CITY PLAN COMMISSION**THURSDAY, April 23, 2026****FILE NUMBER:** PLAT-26-000095**SENIOR PLANNER:** Hema Sharma**LOCATION:** between Clarkwood Drive and Camp Wisdom Road, east of Clark Road**DATE FILED:** March 26, 2026**ZONING:** CR**CITY COUNCIL DISTRICT:** 3**SIZE OF REQUEST:** 6.178-acres**APPLICANT/OWNER:** Texaz Perceptions Partners, LTD

REQUEST: An application to create one 6.178-acre lot from a tract of land in City Block 8597 on property located between Clarkwood Drive and Camp Wisdom Road, east of Clark Road.

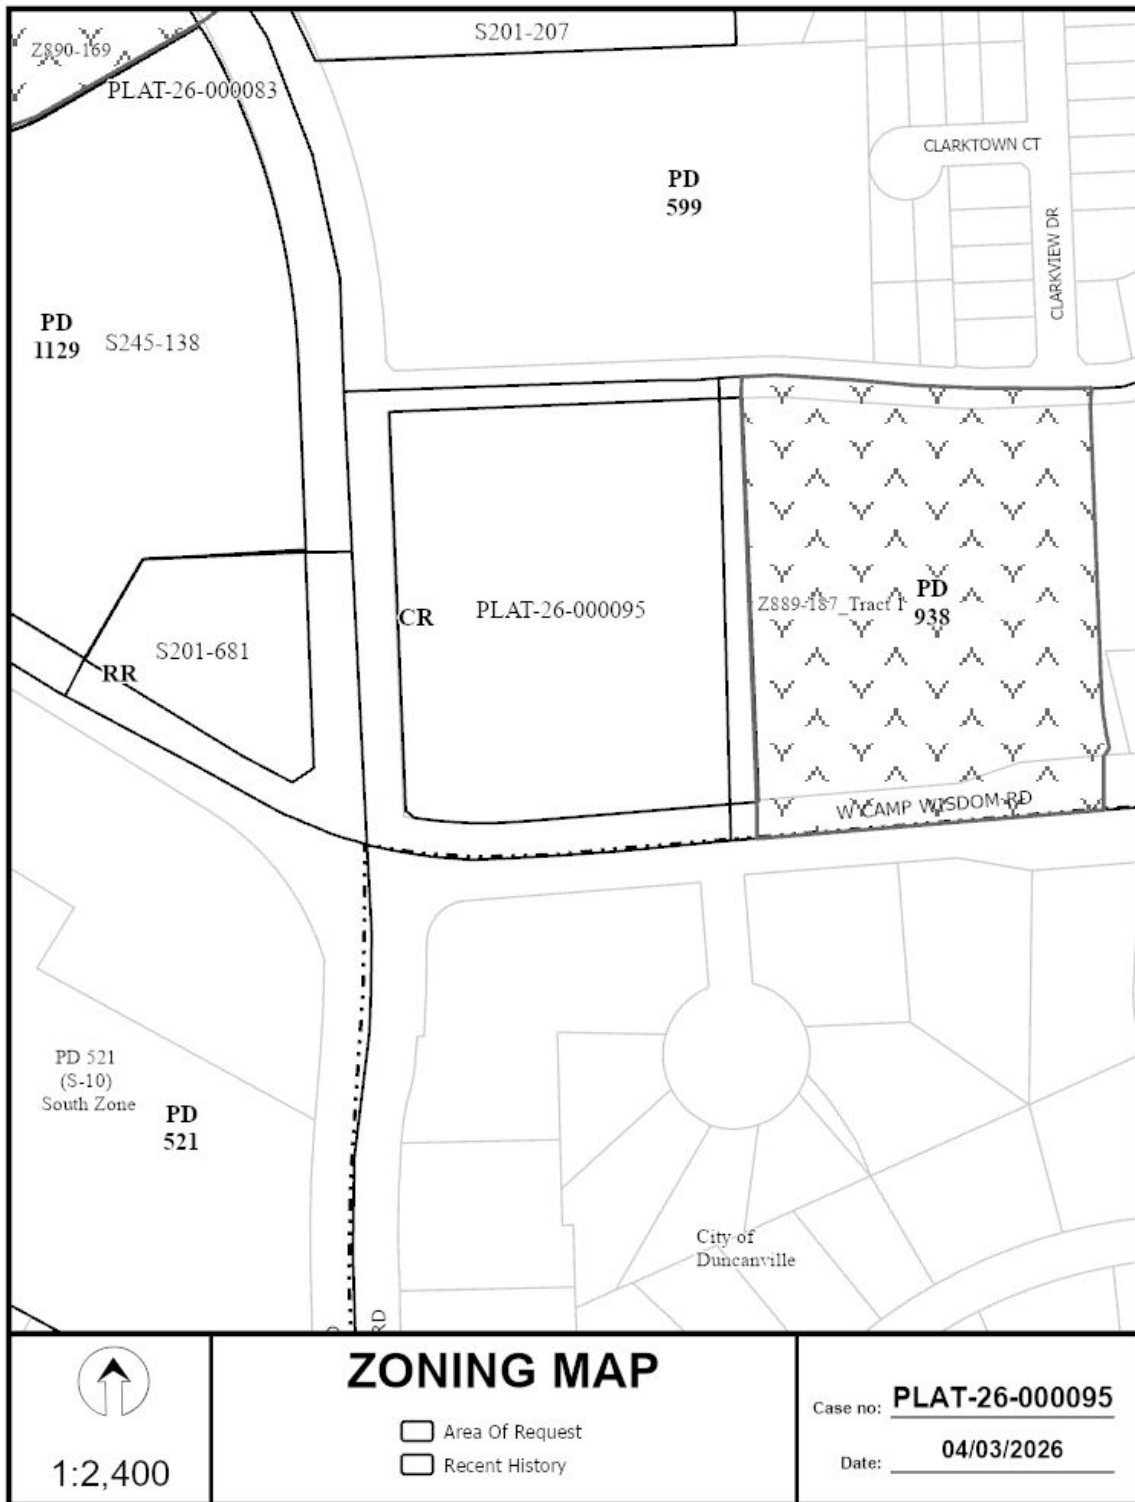
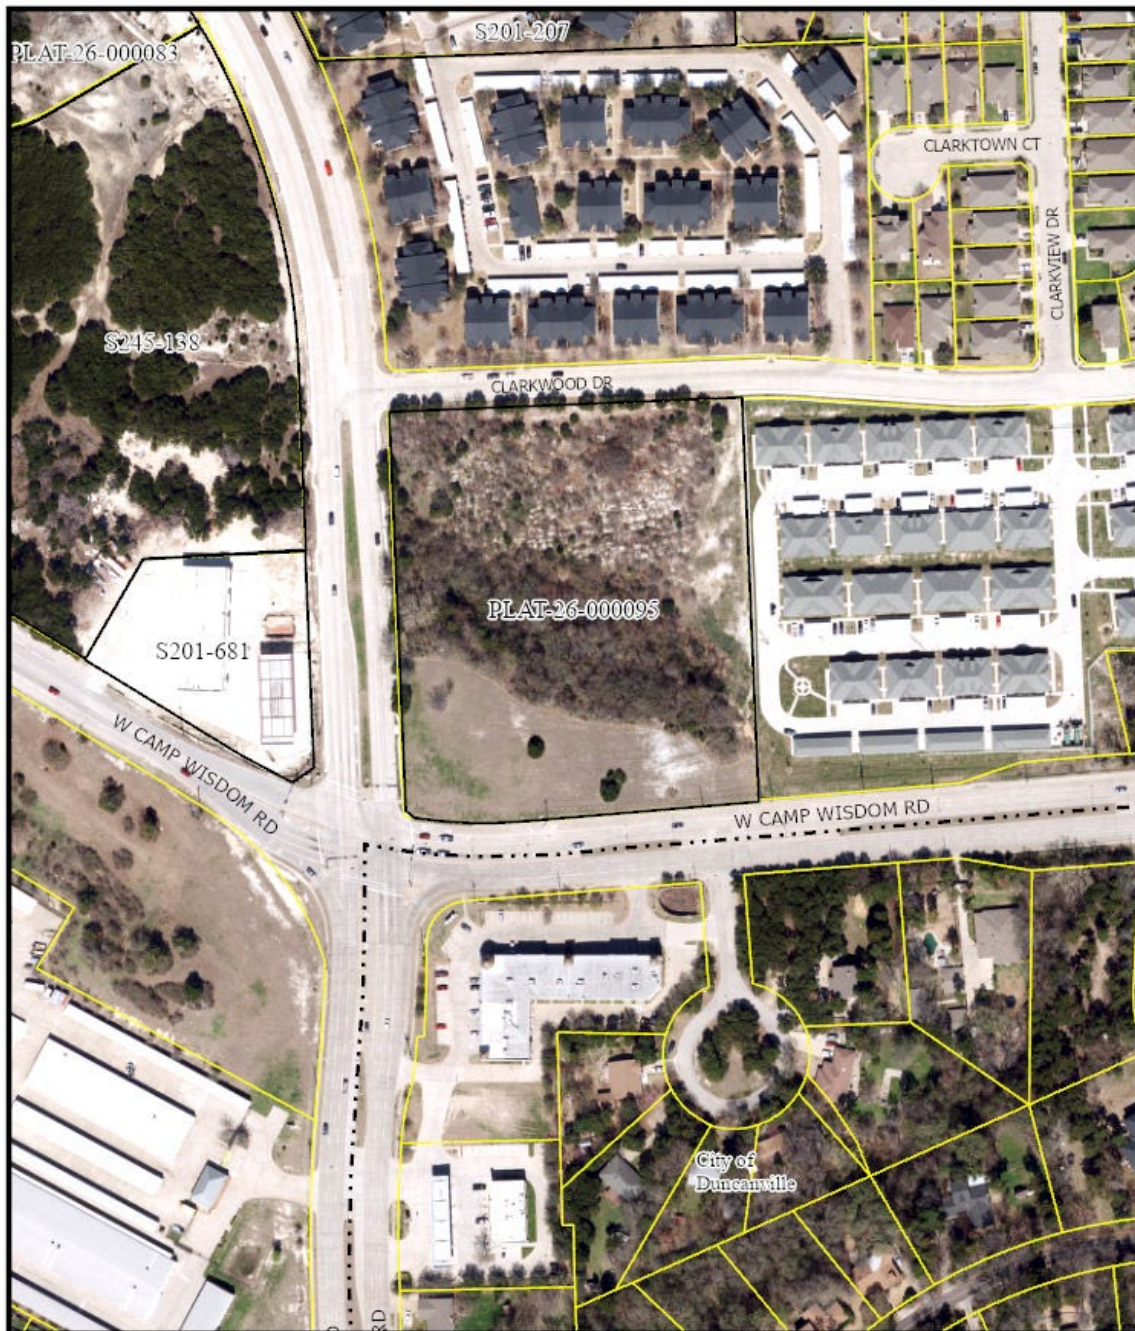
21. Prior to final plat, submit a completed final plat checklist and all supporting documents.
22. On the final plat, show recording information on all existing easements within 150' of property.
23. Clearly label each side with the appropriate jurisdiction.

27. Prior to the final plat, remove Metal Post with Cable encroachment area shown on Clark Road and provide written confirmation and pictures to Real Estate. Please confirm who owns the solar camera in Clark Road right-of-way and the purpose of the solar camera.
28. On the final plat, change W. Camp Wisdom Road (old Co. Rd 47)" to " Camp Wisdom Road (FKA County Road No. 47)". Section 51A-8.403(a)(1)(A)(xii).
29. On the final plat, change "Keywe Place" to "Keywe Place (FKA Key West Place)". Section 51A-8.403(a)(1)(A)(xii).
30. On the final plat, identify the property as Lot 1 in City Block B/8597.
